MIPS R4000PC/SC Errata, Processor Revision 2.2 and 3.0

May 10, 1994

Figure 1a: Power-on Reset or Cold Reset - Workaround for Bug# 54

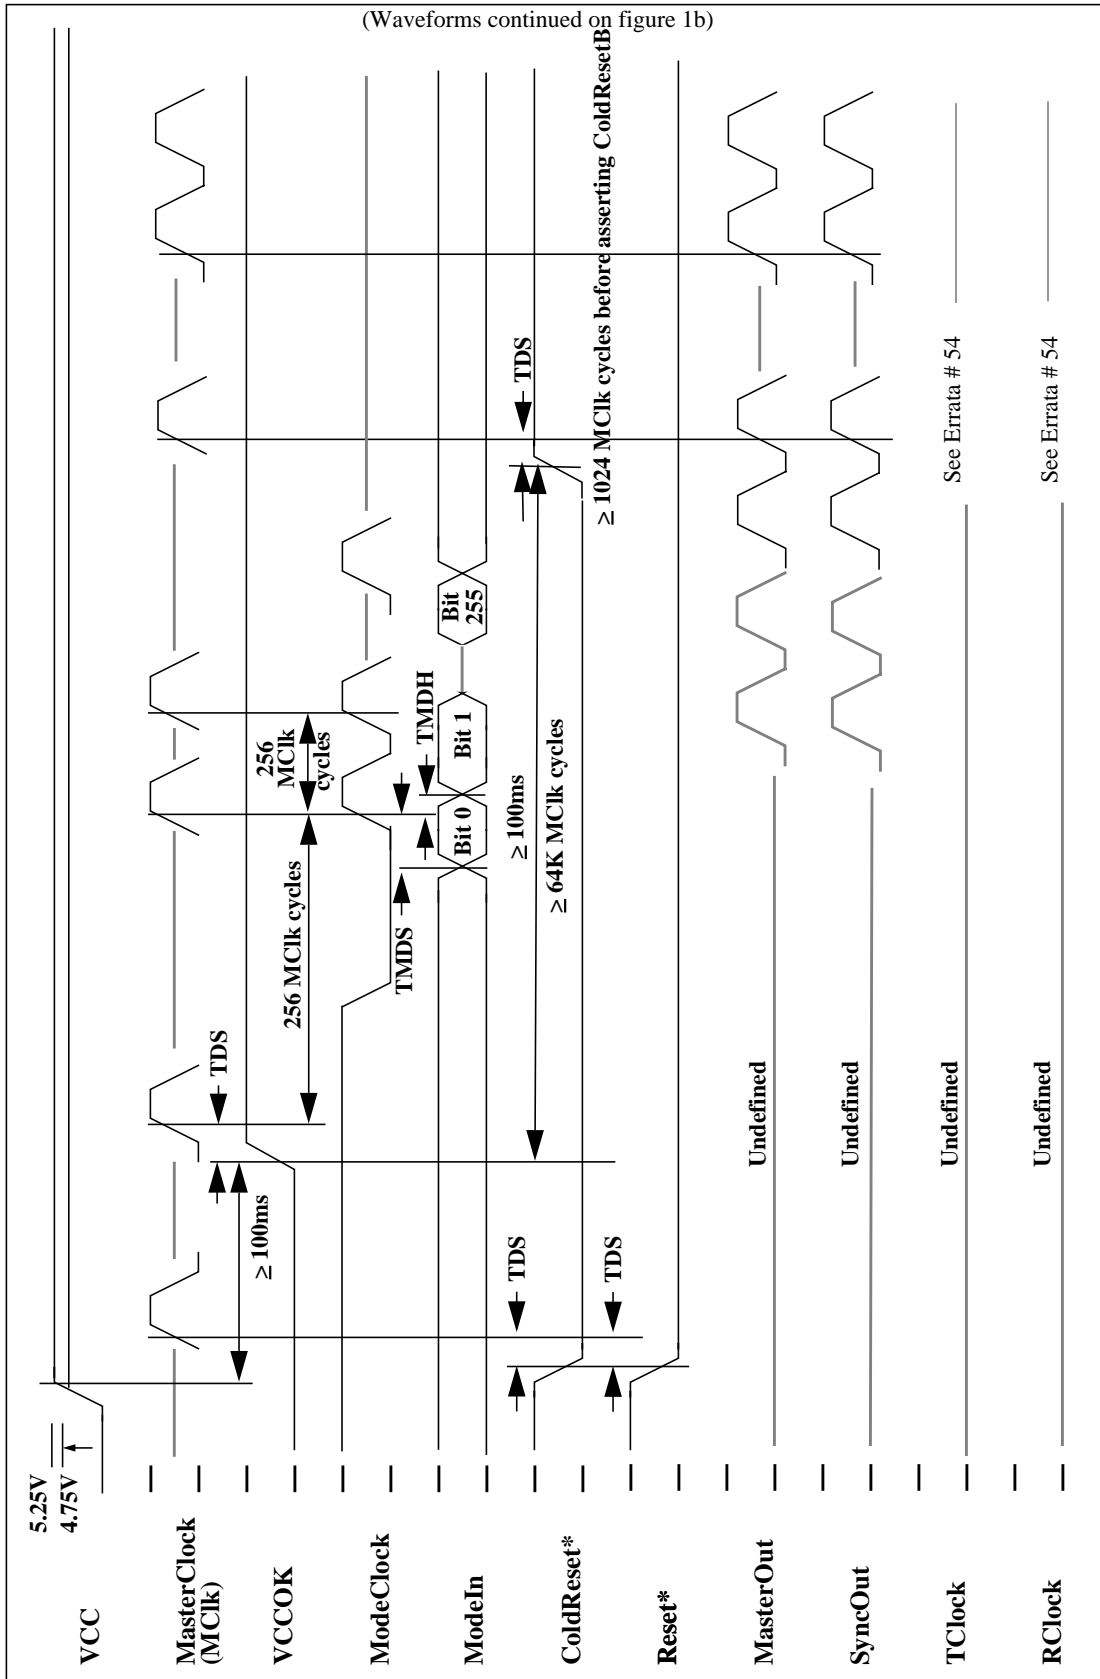
- 54.** R4000PC, R4000SC: During the power up sequence, the period of TClk and RClk may not be as expected for at least 1024 MasterClock cycles following the de-assertion of ColdResetB. The above bug is true for all system interface divisors. Furthermore, if the system interface divisor other than 2 (i.e. 3,4,6 & 8) is used, TClk and RClk's rising edge may not align to the rising edge of the MasterClock, as specified.

This may not be a problem for systems using only TClk for the external logic. However, certain systems like -

- 1) systems using MasterClock for the external logic
- 2) system with external PLL which needs to lock with the internal PLL
- 3) systems with multiple processors operating in lock-step

this bug may cause problems.

Thus, for system with interface divisor set to two, the only violation will be that the TClk and RClk's period might not be valid within 64 MasterClock after the ColdResetB is de-asserted.

Workaround: Assert a second ColdResetB after at least 1024 MasterClock cycles from the de-assertion of the first ColdResetB. ResetB should remain asserted until at least 64 MasterClock cycles following the de-assertion of the second ColdResetB. TClk and RClk will then be valid 64 MasterClock cycles after the de-assertion of the second ColdResetB and their edge alignment with respect to MasterClock will be as specified. Figure 1a & 1b show the waveforms in more detail. Note that the waveforms in Figure 1b are continuation of the those in figure 1a.
